CONSULTEE RESPONSE (Council's Arboriculturist)

Reference: AW/138/22/T

Location: 20 The Oaks, Aldwick, PO21 3AE

Proposal: 1 no. oak tree (T1) crown lift to 5 metres, remove epicormic growth from the trunk and thin out the canopy by 20%, remove deadwood

Figure 2 Positions of final cuts

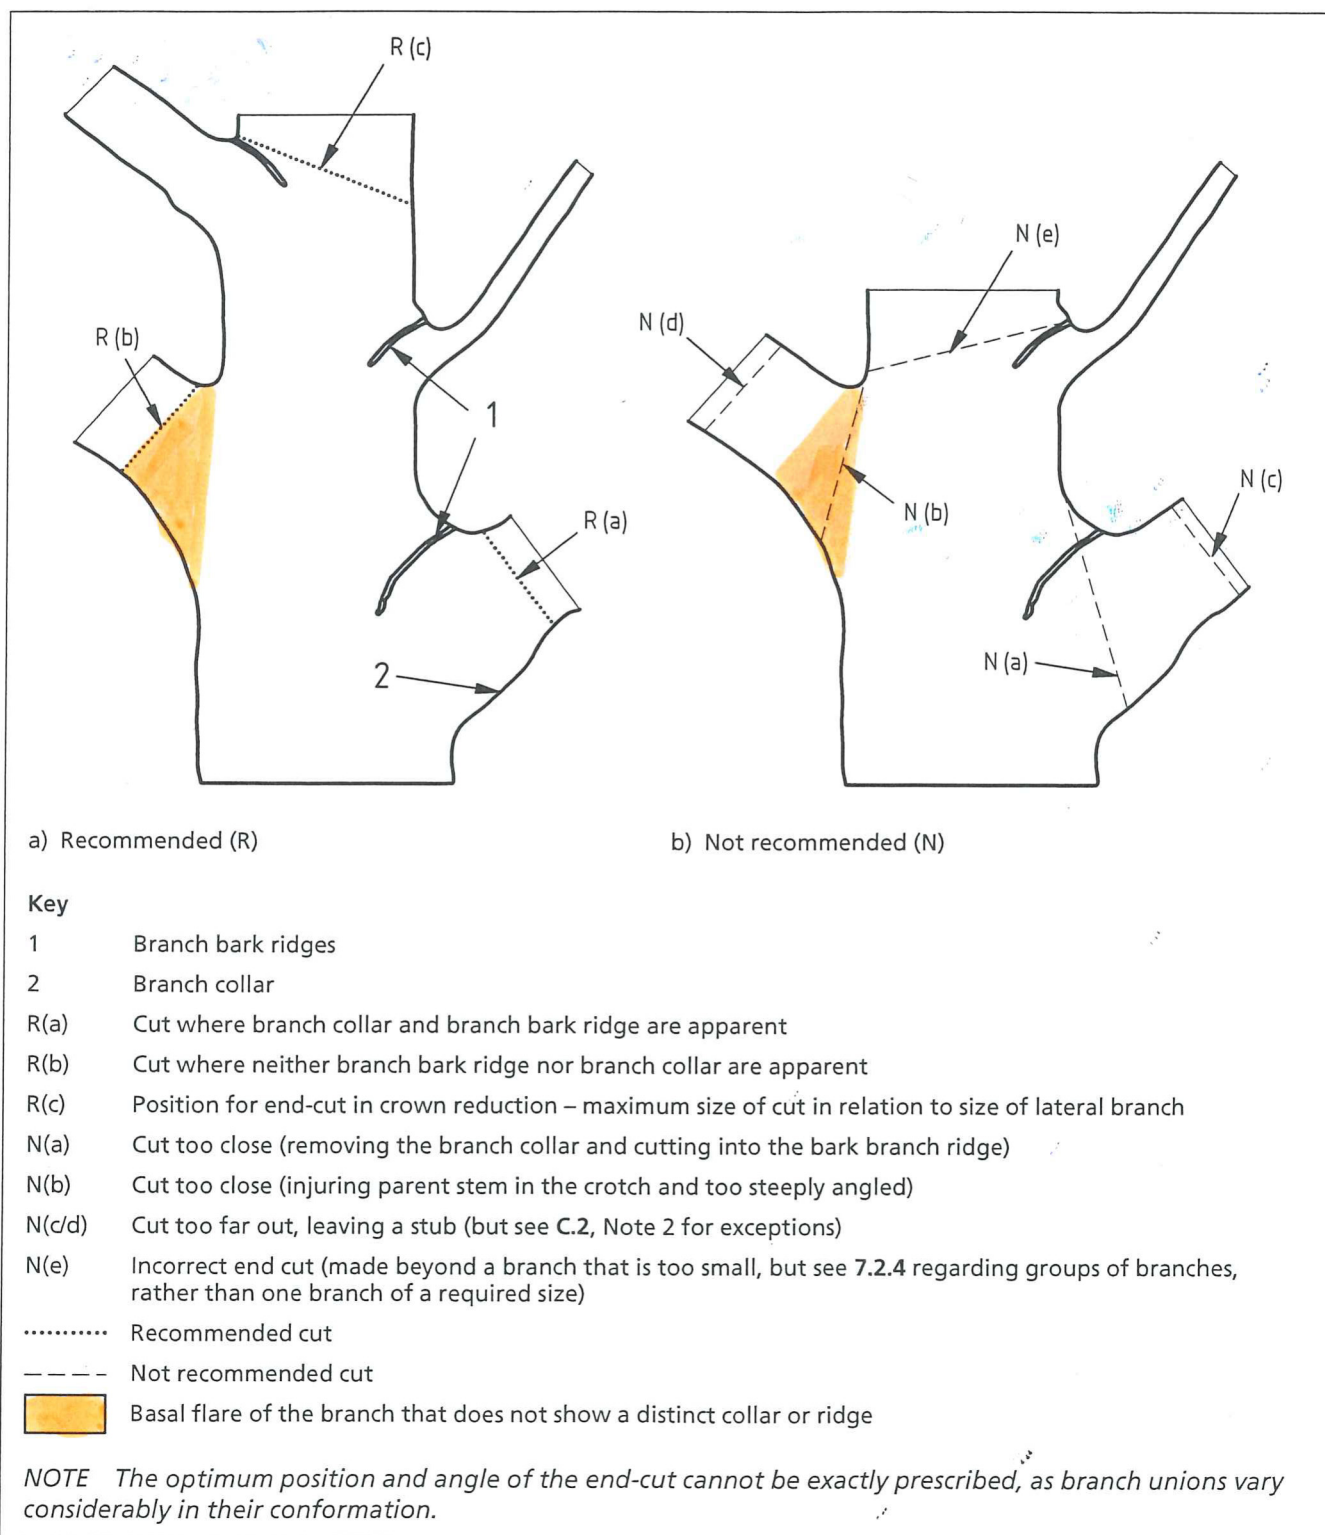
Part a) Where whole branches are to be removed and final cuts made close to the trunk or branch union they are to be made as shown in Figure 2 of BS3998:2010
